Farnborough Airport

Airspace Consultation Feedback Report **Part C** Analysis of the Additional Consultation

Feedback Report Part C

Figure 2 Airspace volume CTA7 revised post-consultation (pink)

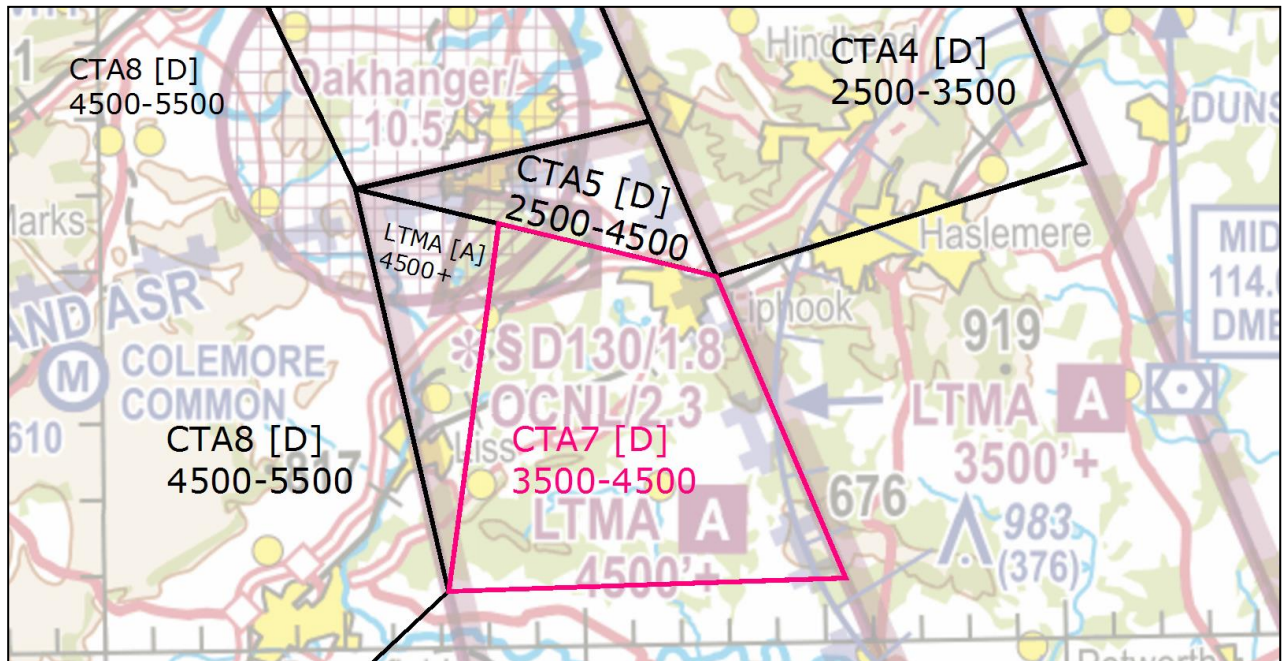
2.12. Comment: Impacts on other airspace users, known as General Aviation or GA. (Specifically, the volume of airspace known as CTA7.)

We explained in the additional consultation document (Ref 3) why CTA7's width needed to increase. Comments received were mainly about the widening of CTA7 impacting the typical route gliders take, when flying between Lasham (Lasham Gliding Society) and Parham (Southdown Gliding Club). Specifically how the previous (smaller) version of CTA7 (known as Option 34) was not ideal but manageable, and the widened version (Option 36) was not, because the heights and distances involved in flying beneath or around the orange area could increase the likelihood of a non-airfield landing.

In response to these comments CTA7 has been reduced in size as indicated by the pink outline in the chart above. The width to the west has been reduced. The adjacent overlying airspace is the LTMA with base 4,500ft, and CTA8 further west abuts the LTMA also at 4,500ft.

The modified airspace boundary decreases the distance glider pilots would need to fly below CTA7 by up to 3.7km. Based on gliding performance data supplied by Southdown Gliding Club this would reduce the likelihood of a non-airfield landing.

Figure 4 Left, Middle and Right (each showing the same map area)

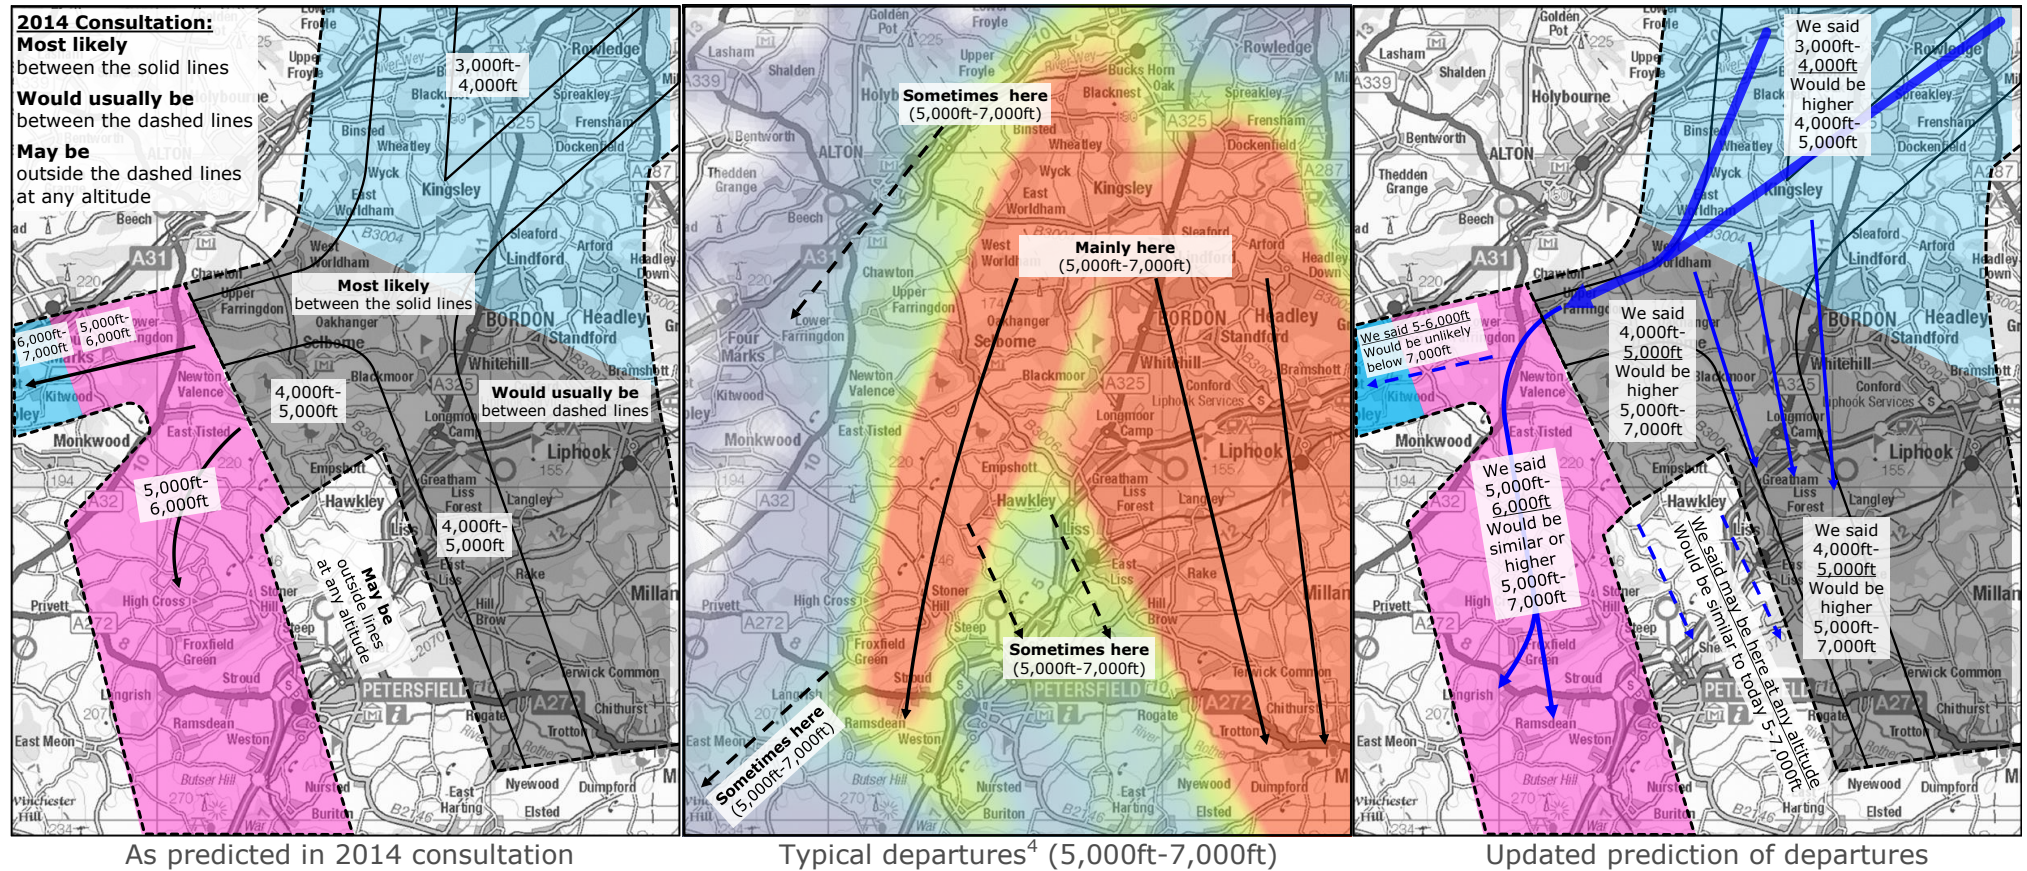
- 5.4. Figure 4 Left shows the 2014 consultation predicted flight-paths and altitudes. (Ref 5, combining Figure B9 p.B41 and Figure C9 p.C36)
- 5.5. Figure 4 Middle shows that today, typically, departures sometimes overfly Petersfield and Liss between 5,000ft and 7,000ft.

- 5.6. Figure 4 Right shows our updated prediction that, sometimes, Petersfield and Liss would be overflown similar to today.
- 5.7. The vast majority of our departures would stay within the 2014 consultation lines, and are predicted to meet or exceed the altitudes shown in the 2014 consultation.

- 5.8. Those departures flying outside the 2014 lines would behave similarly to today, so the impacts on eastern Petersfield and western Liss would be similar also, hence there are no consultation process implications. This is updated information.
